## UR Family

# Version 8.0x

## Release Notes

GE Publication Number: GER-4882G

### Changed "Error creating offline device" message on status bar when using URS file to "Add Device to Offline Window" option

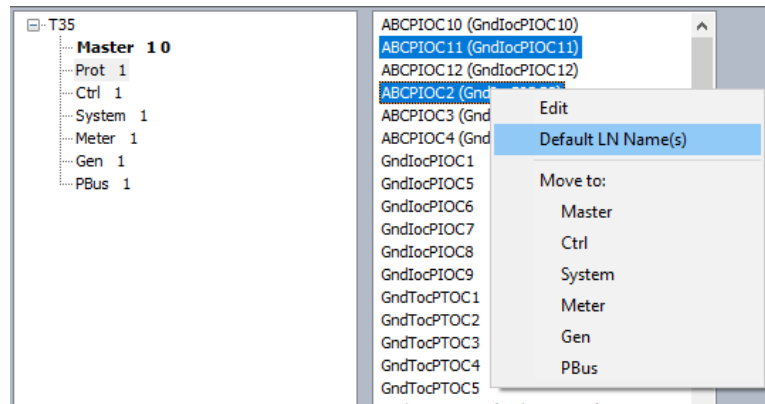
Description: When adding an offline device using a .urs file, the status bar shows "Error creating offline device." An untimely device integrity check during automatic SCL file generation fails, causing the error to be logged on the status bar. However, the device is added successfully to the Offline Window area.

The new release eliminates the automatic SCL file generation after a "Add Device to Offline Window" operation that uses a .urs file. A warning prompts the user to initiate SCL file generation manually using "Update SCL Files."
